Owner / Applicant:	Elizabeth Lacasia
File No:	PLN2021-00478
Location:	779 San Carlos, El Granada
APN:	047-105-020
CDRC Meeting:	Meeting <u>Link</u>

Coastside Design Review Permit

CDRC renders a no decision by split vote on Project PLN2021-00248.

SHEET TITLE: EAST AND WEST ELEVATION

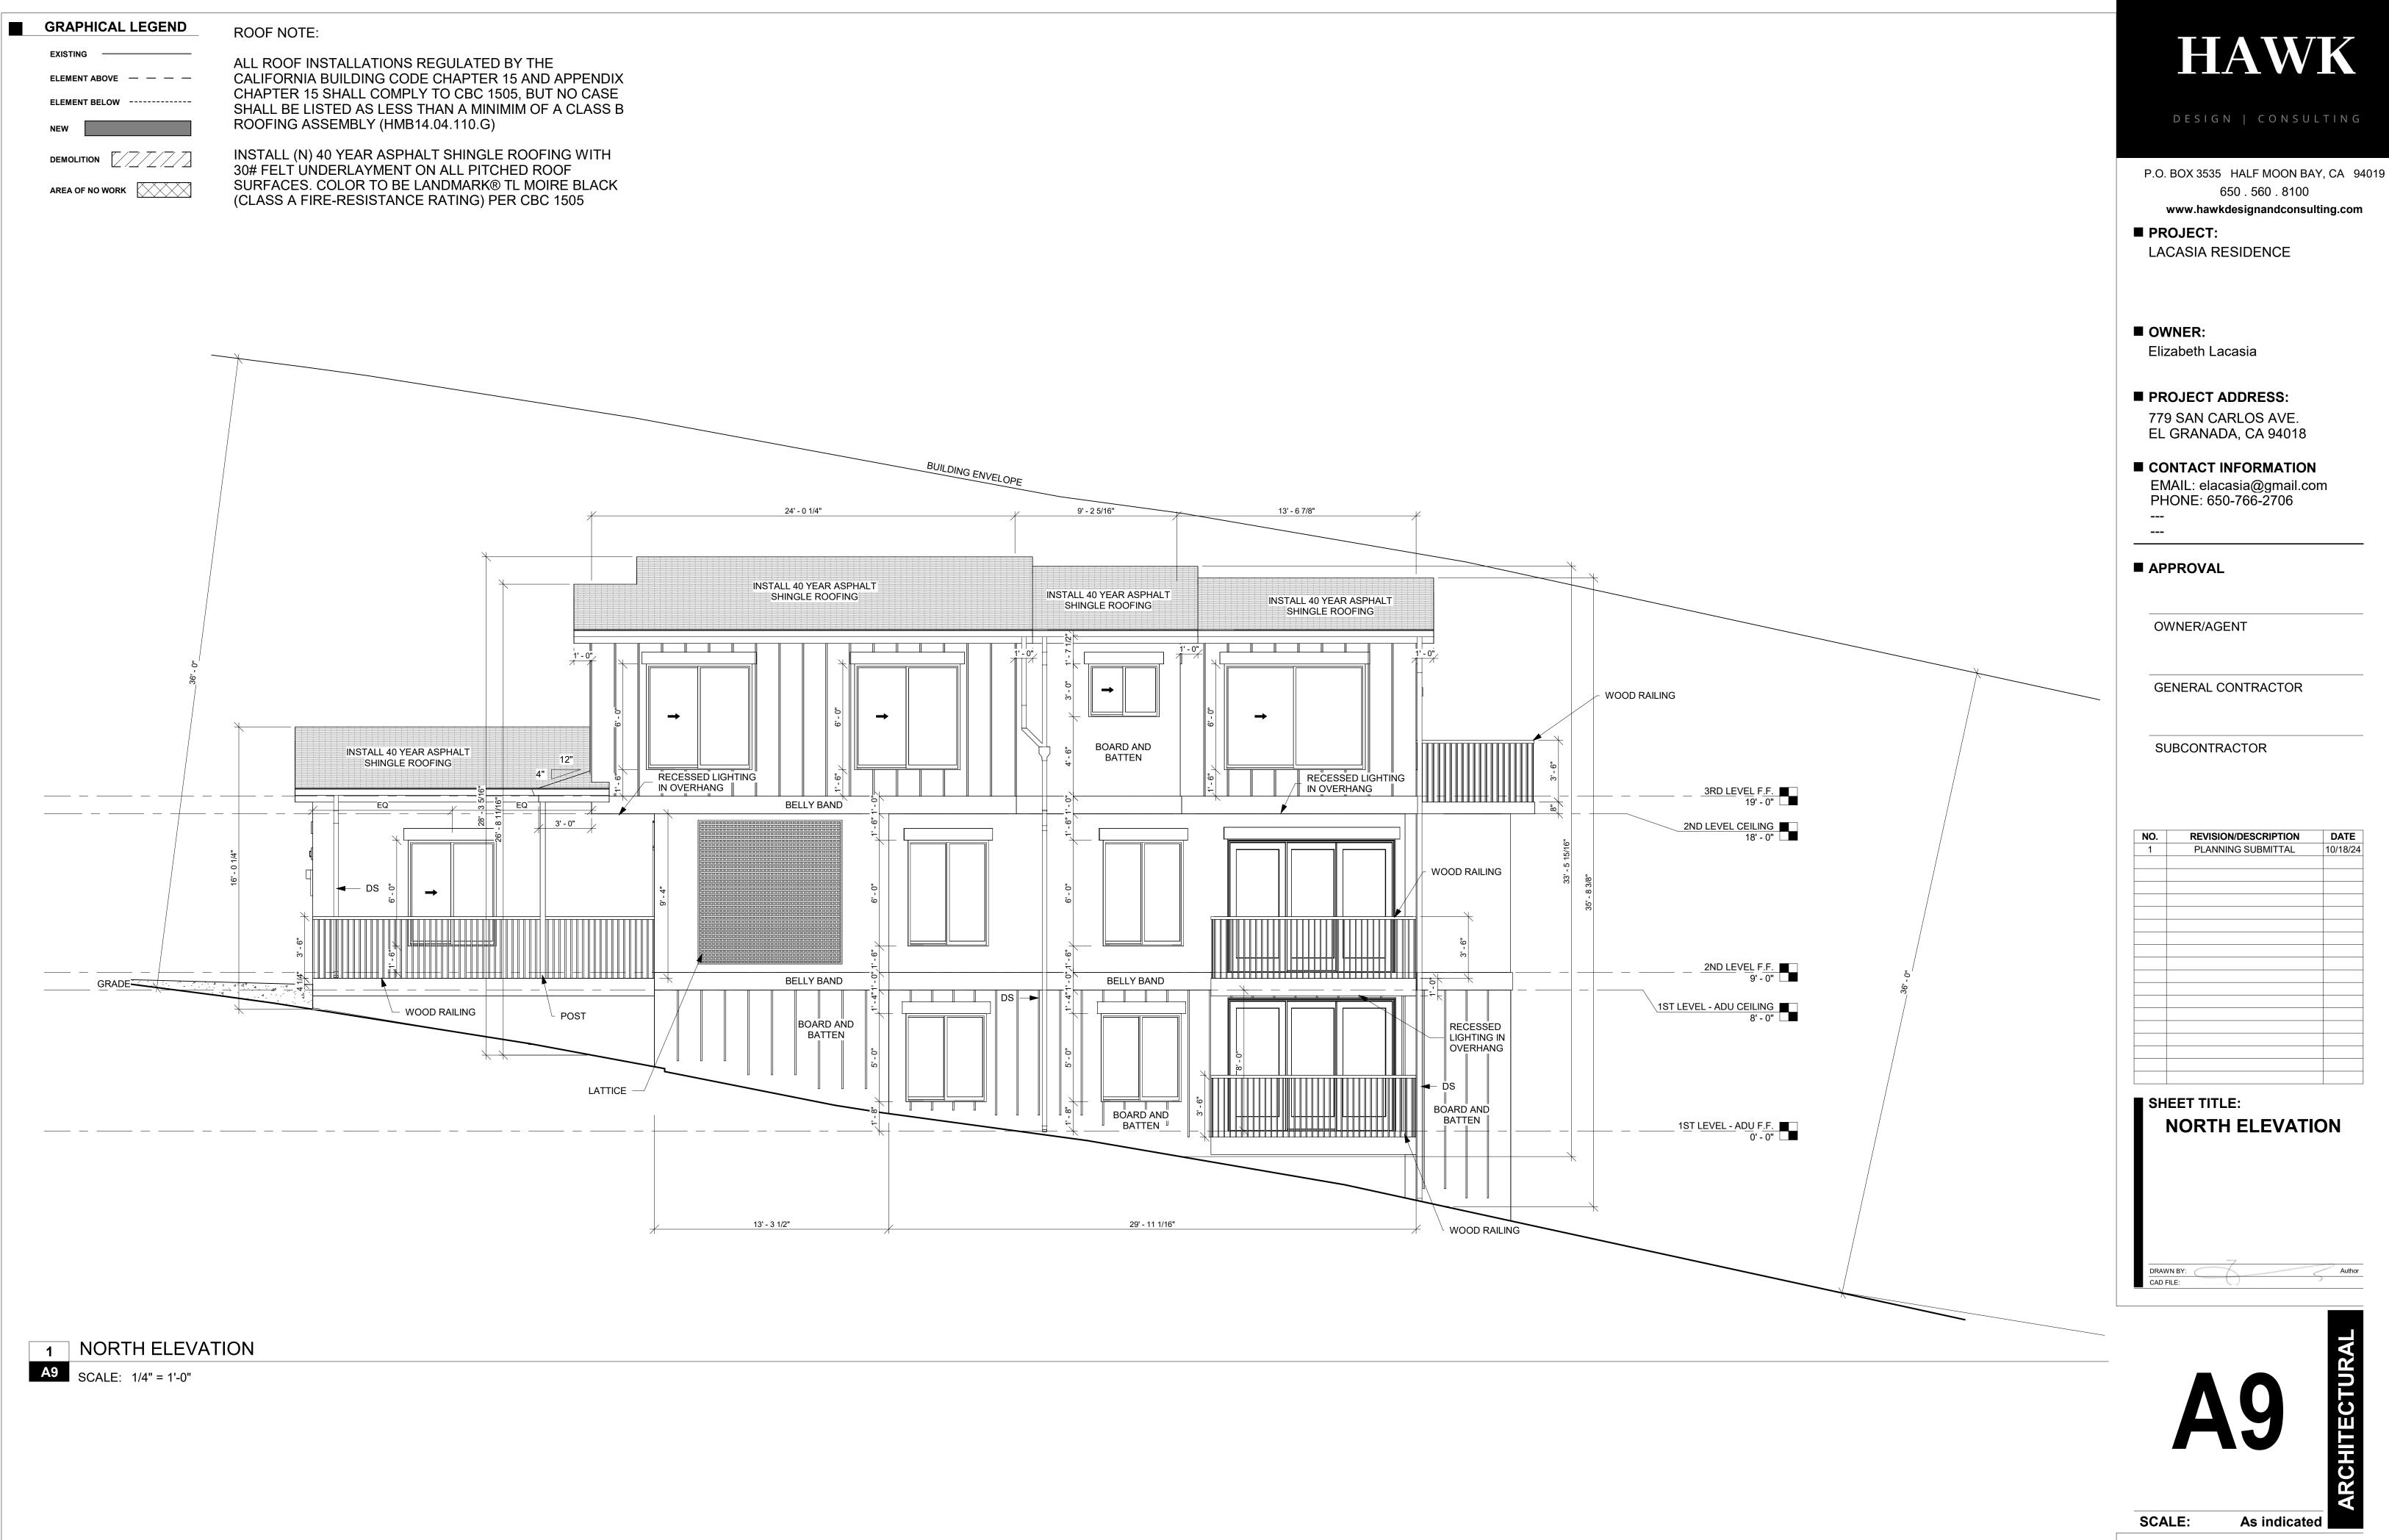
The previously approved proposed building was significantly smaller and less "boxy" with a smaller upper floor than the currently proposed property. In addition to the recommendation by the CDRC to utilize a different exterior facade material (e.g., wood) between the third level and levels one and two, the committee also recommends addressing the massing towards the back of the structure as shown on the South Elevation (sheet A10). The previously approved building stepped down from third to second floor and more closely followed the contour of the natural grade than the current design which has "tallest" wall on the downslope.

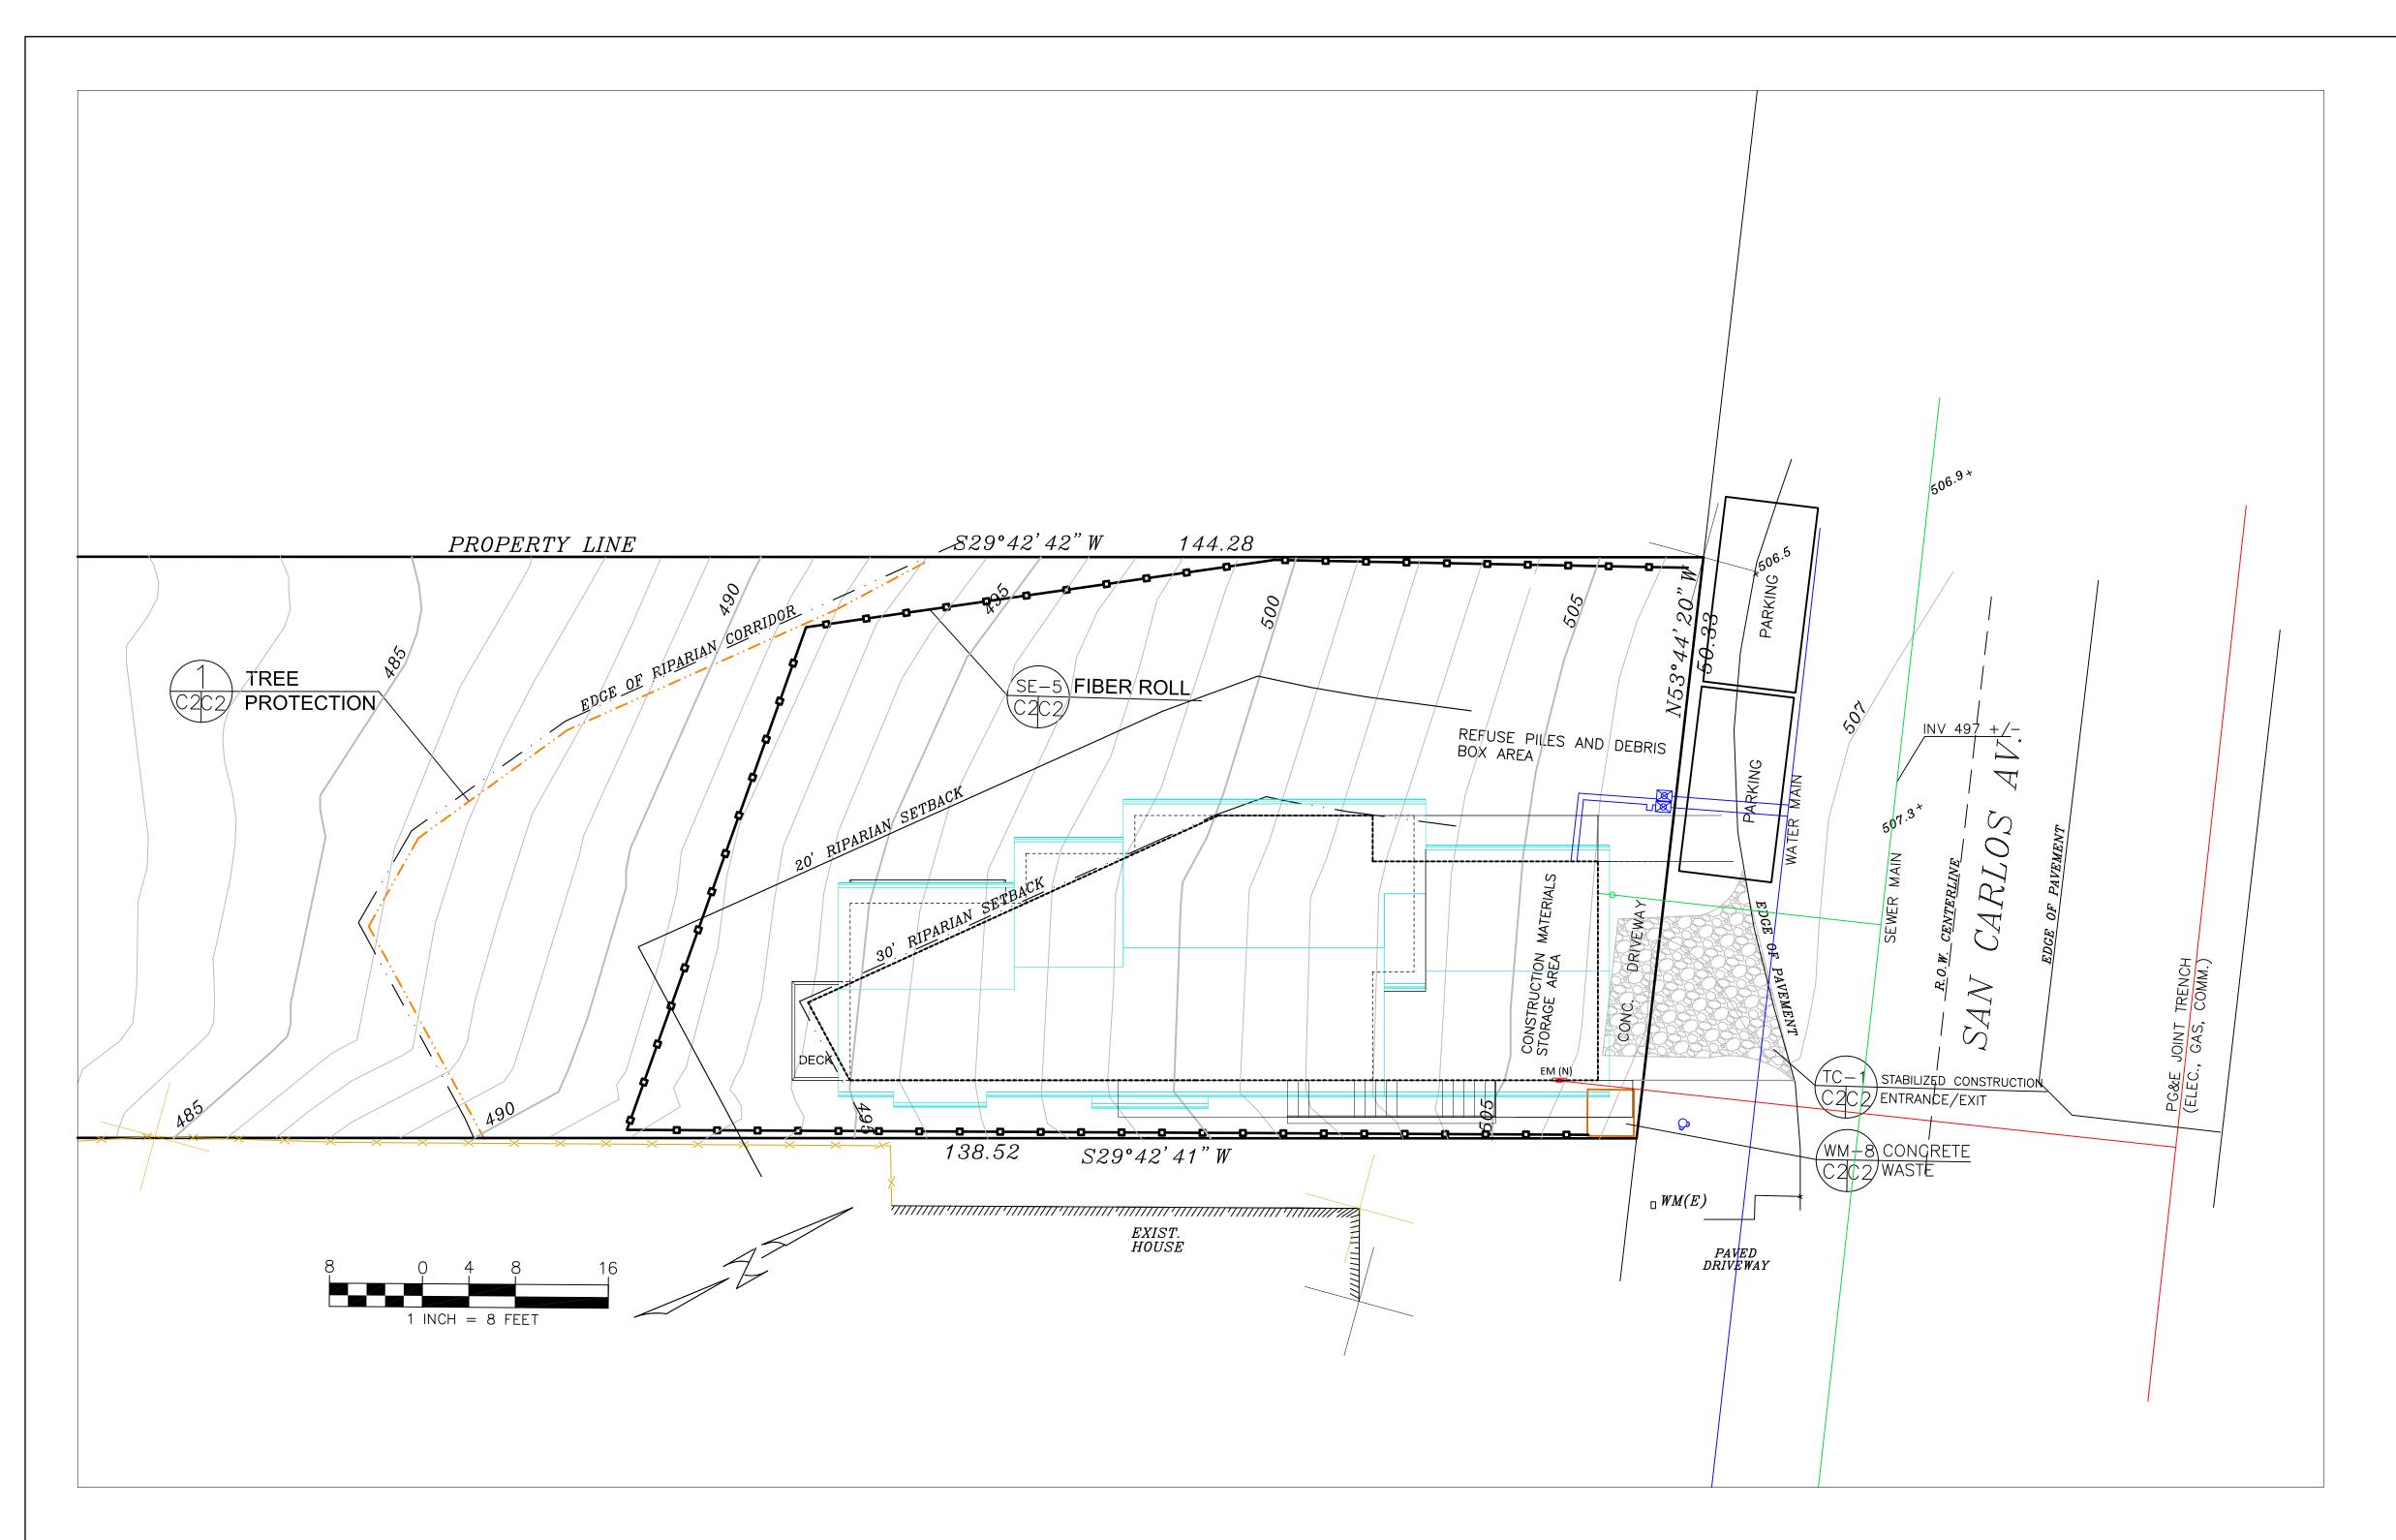
- 1. Spread footings at the ground level appear to encroach into the 30' riparian zone setback. Design should reflect footing width below grade.
- 2. Committee recommends a building section to understand the buildup from floor to ceiling.
